Correspondence Between
Staff and Applicant
Approval Letter

RE: Senior Living at McDowell Mountain Ranch; 8-ZN-2019 and 5-AB-2019

The Planning & Development Services Division has completed the review of the above referenced development application submitted on 7/1/19. The following **2nd Review Comments** represent the review performed by our team and is intended to provide you with guidance for compliance with city codes, policies, and guidelines related to this application.

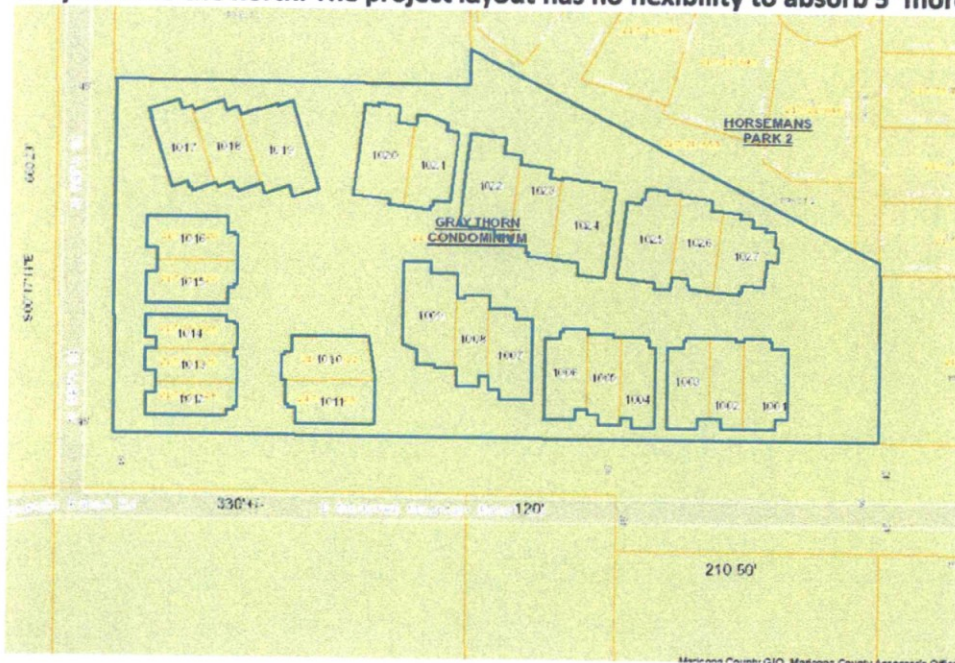
2. Specialized residential healthcare facilities shall not exceed 80 beds per gross acre and Minimal residential healthcare facilities shall not exceed 40 units per gross acre (Section 5.2203). These sections are not calculated cumulatively. If there is a mix of Specialized and Minimal on a property, staff has applied the more restrictive Minimal requirement to the entire site. The site plan has the maximum allowed on each of these based on 5.658 gross acres which is the entire property. Please revise the calculations on the site plan. **Response: Done**

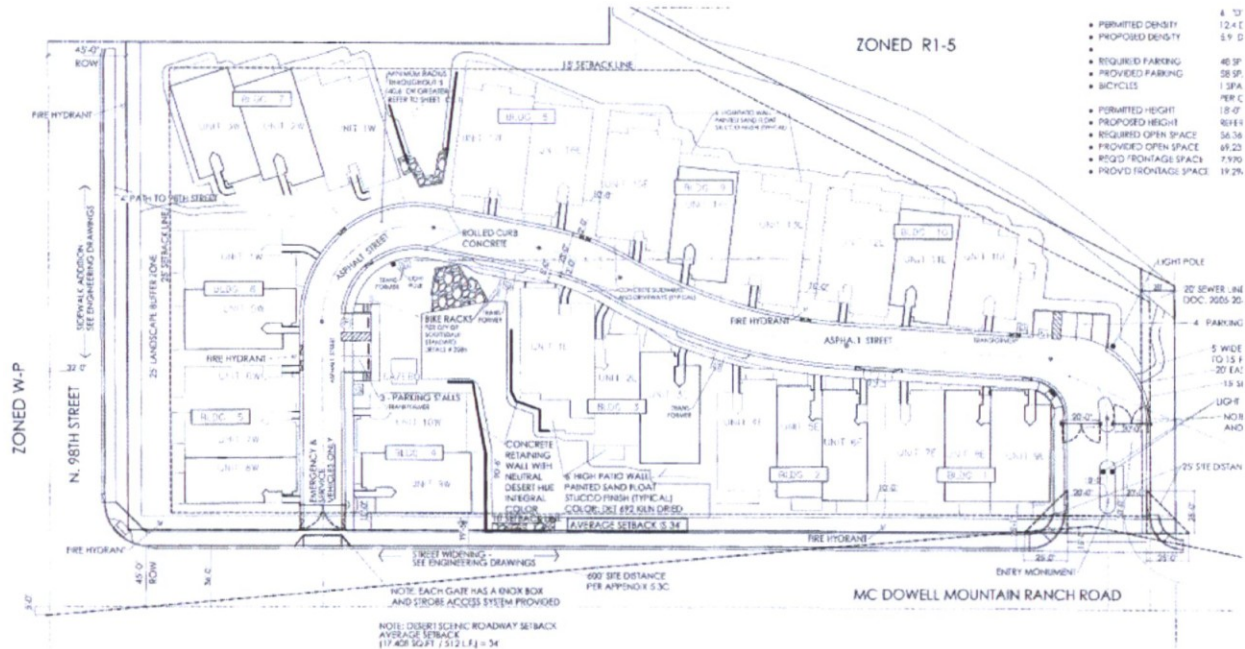
Corridor or Buffered Roadway. *Per the 02/26/2004 City Council report, 1-GP-2004 did not "identify" MMRR by name or as a one-mile/half mile road per the Planning staff report abstract below.*

Following discussion at the Planning Commission hearing and from receiving input from citizens, staff is recommending a third level of scenic roadway designation called the "Desert Scenic Roadways". Desert Scenic Roadways are the one-mile and half-mile roads within the ESLO district that are not already designated as a Scenic Corridor or Buffered Roadway. Setbacks of these roadways will vary based on the topography and specific site conditions. These roadways will rely on the placement of NAOS and zoning setbacks to achieve an open space corridor along the road. Desert Scenic Roadways will apply to areas with existing and future proposed development, so the open space corridor will meander and not be a strict dimension. It will be important to examine new development on a case-by-case basis to ensure that the ESLO NAOS priorities (such as wash preservation and continuous open space) are

As stated before, MMRR is not a Desert Scenic Roadway as defined above as it exists for only 2 circuitous miles from 98th Street curving northward to Bell Road. Throughout its 2-mile length there is no portion at a one-mile/ half-mile spacing. The length and alignment are shown on the map below and the orange line is the half-mile mark.

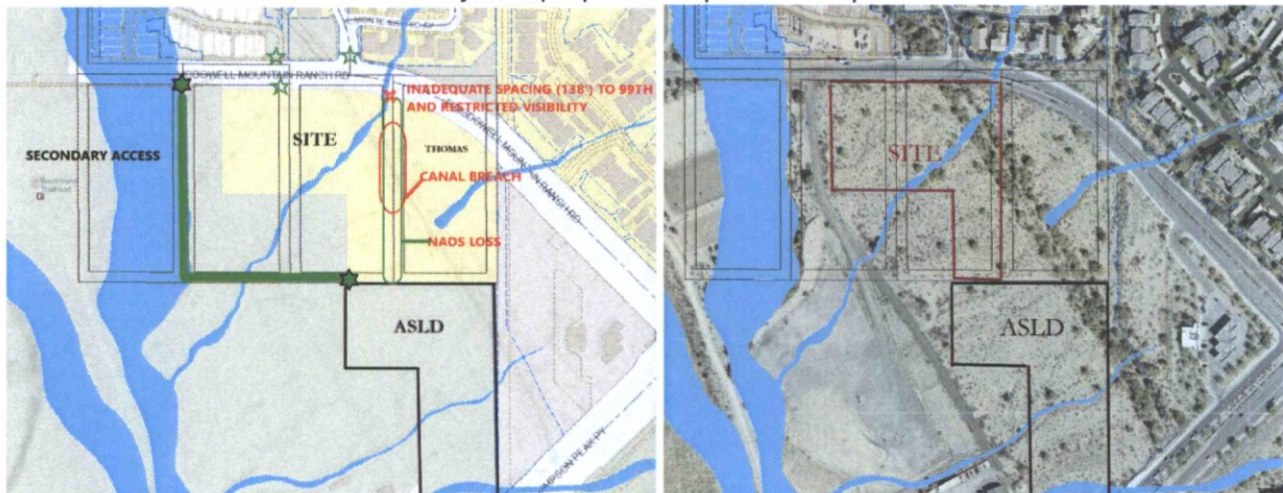
6. Specialized residential healthcare facilities shall not exceed 80 beds per gross acre and Minimal residential healthcare facilities shall not exceed 40 units per gross acre (Section 5.2203). The site plan has the maximum allowed on each of these based on 5.658 gross acres which is the entire property. Please revise to separate each and apply the partial area of the site to each. ***The zoning ordinance does not segregate the two classifications. The densities for both uses are cumulative and therefore not applied to partial areas of the site (from a practicable standpoint there isn't a way to allocate portions of the site as both uses are within the same building).***
